ANNOTATED SITE PLAN – CUP APPLICATION

8924 Mount Curve Road, Bloomington, MN 55438

PROPOSED GARAGE STUDIO FLOOR PLAN

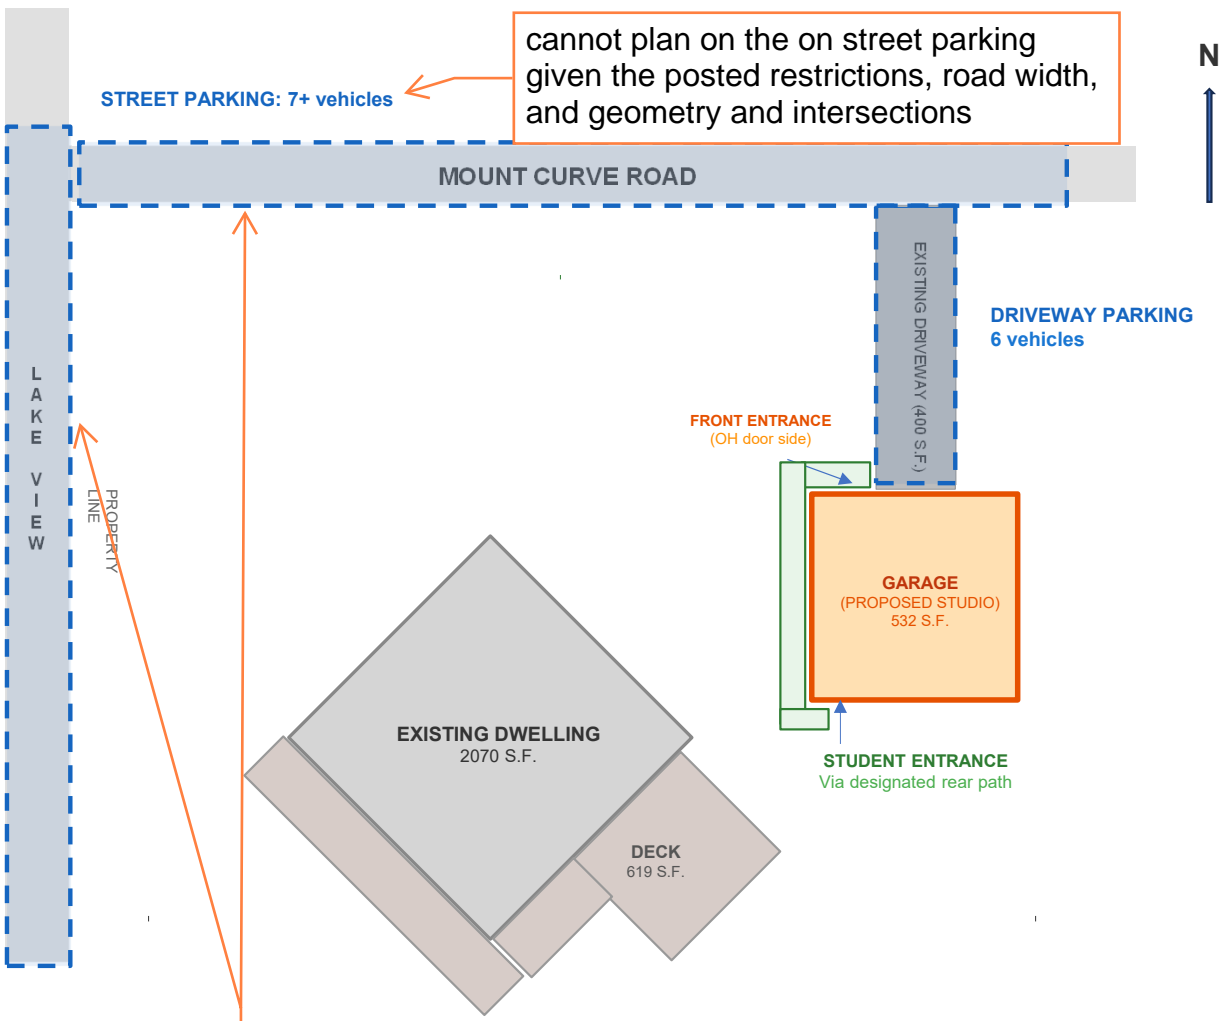
cannot plan on the on street parking given the posted restrictions, road width, and geometry and intersections

These roads are all posted as No Parking due to the narrow street width (estimated to be 20' - 25' wide)

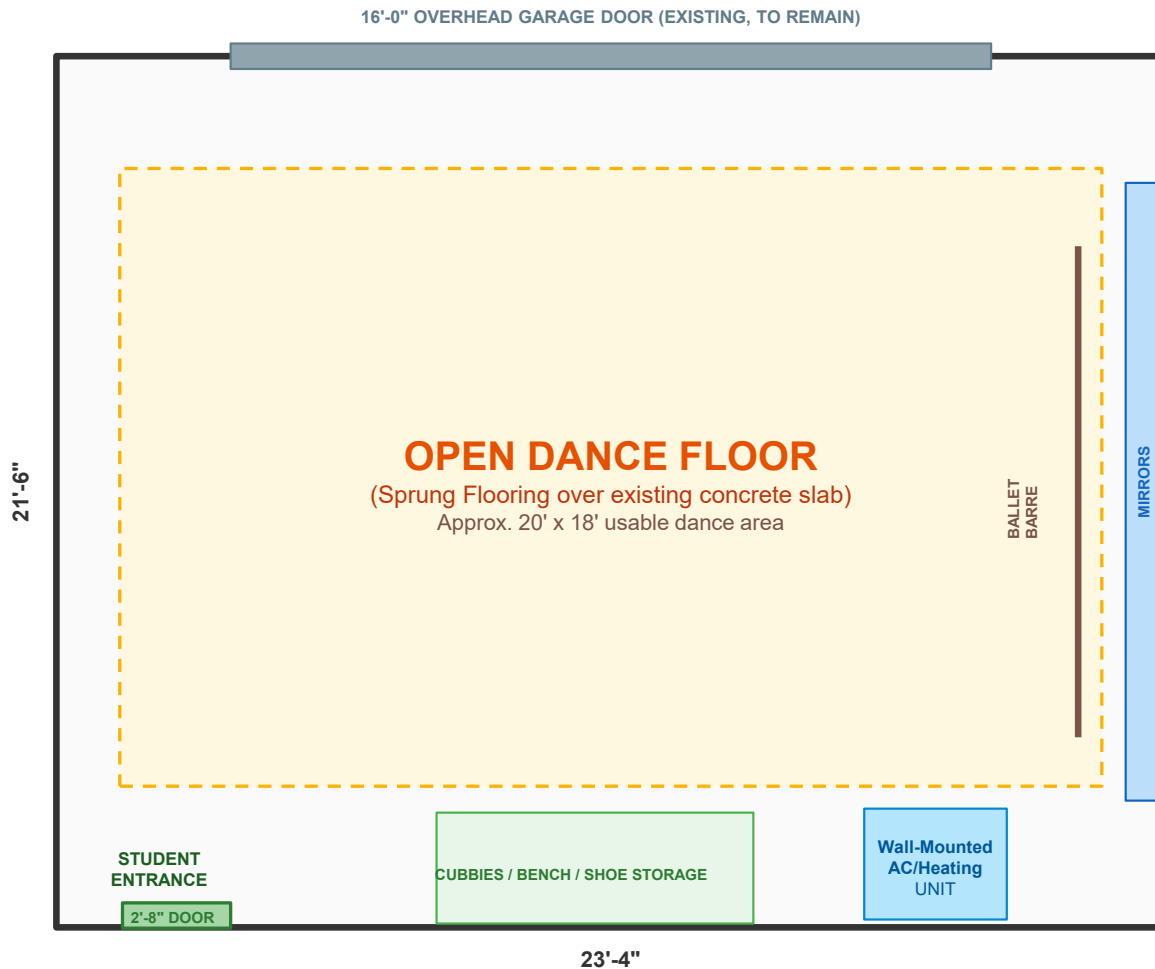
Heat detectors may be required in storage space(s) above the dance studio. Provide at least 1 fire extinguisher in the dance studio.

Minimum 1 exit door from the space. Overhead garage door does not qualify.

Remove or provide appropriate storage cabinets for products considered hazardous materials.

Permits are required if any remodeling work is being done - including alterations/upgrades to electrical, plumbing, or mechanical systems.

Call Building & Inspections if questions - 952-563-8930.
